**UNITED STATES  
NUCLEAR REGULATORY COMMISSION**

**SUBJECT: THREE MILE ISLAND, UNIT 2, INDEPENDENT SPENT FUEL STORAGE  
INSTALLATION INSPECTION REPORT 072-00020/2016-001**

Dockets No.: 072-00020  
Licenses No.: SNM-2508  
Report No.: 072-00020/2016-001  
Licensee: United States Department of Energy – Idaho Operations  
Facility: Three Mile Island, Unit 2  
Independent Spent Fuel Storage Installation  
Location: Idaho Operations Office  
1955 Fremont Avenue  
Idaho Falls, ID 83415  
Dates: July 20-21, 2016  
Inspector: Eric J. Simpson, ISFSI Inspector  
Fuel Cycle and Decommissioning Branch  
Approved By: Jack E. Whitten, Chief  
Fuel Cycle and Decommissioning Branch  
Division of Nuclear Materials Safety

Figure 1, TMI-2 ISFSI

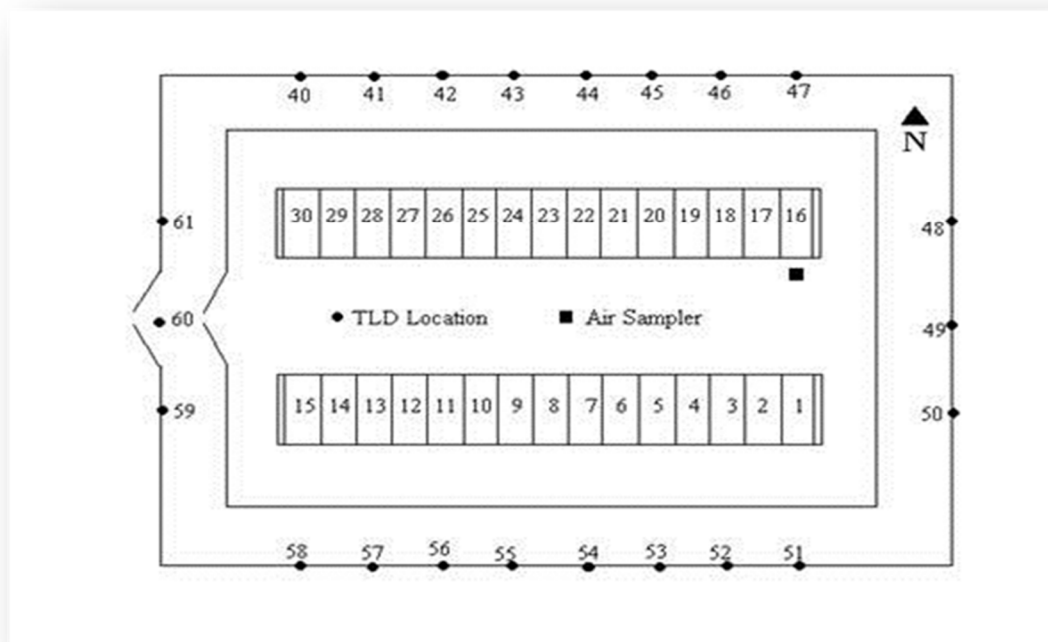
Thirty HSMs were situated on the TMI-2 ISFSI pad, with all but one containing spent fuel from the damaged TMI-2 reactor. The additional HSM situated on the pad was to serve as a backup storage location if problems arose with existing HSMs or DSCs. The 30 storage casks were arranged in two east-west rows of 15 with the door openings facing inward. The HSM casks 1–15 were situated in the southern row and casks 16–30 on the northern row (see Figure 1, above).

The inspection of the physical condition of the ISFSI found the concrete to be in good condition. The NRC inspector did not observe any vegetative growth in or around the concrete pad or any flammable or combustible materials stored on the ISFSI pad. A low volume air sampler was situated on the ISFSI pad in close proximity to HSM #16. The purpose of the air sampler is to determine radiological effluent releases from the TMI-2 ISFSI.

The physical condition of the concrete HSMs was observed to be very good. Signs of past concrete repairs were evident on many of the storage modules; however, all concrete repairs to the ISFSI were intact and appeared to be free from further degradation. All hardware, doors, latches, and ports installed in the TMI-2 HSMs inspected were in good condition. The NRC inspector utilized a Ludlum Model 19 sodium-iodide gamma survey meter (NRC #033906, calibration due 3/8/2017) to measure gamma exposure rates in microRoentgens per hour ( $\mu\text{R}^1/\text{h}$ ). Radiological conditions were observed and recorded by the NRC inspector on approach to the TMI-2 ISFSI, at the outer boundary locations of the pad, and at the HSM front and rear door locations. Ambient radiation levels at the INL site were elevated due to the influence of radioactive materials stored onsite that were unrelated to materials stored in the TMI-2 ISFSI. Ambient levels were approximately 150  $\mu\text{R}/\text{h}$  on approach to the ISFSI pad front gate. Measurements taken by the NRC inspector at various locations around the pad ranged from 70 – 190  $\mu\text{R}/\text{h}$ . Contact measurements were taken at various HSM front door locations and ranged from 190 – 1100  $\mu\text{R}/\text{h}$  (1.1 milliRoentgens/h). The HSM rear door panel contact measurements ranged for the HSMs from 40 – 500  $\mu\text{R}/\text{h}$ . All measurements were determined by the NRC inspector to be well below Technical Specification 3.2.1 and 3.2.2 dose rate limit requirements of no more than 100 millirem/hour for the front and rear access doors.
